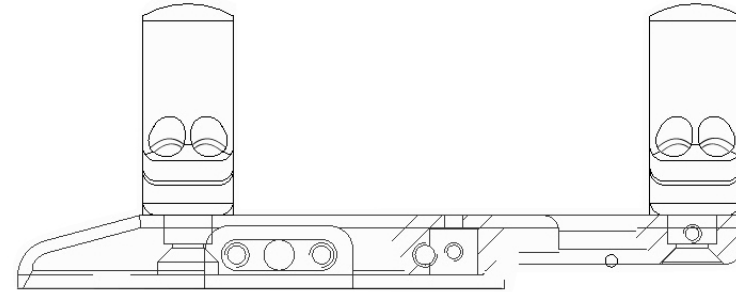
The older version needs M4 screws with normal head and rings, the new version needs M5 screws with counter sunk and rings
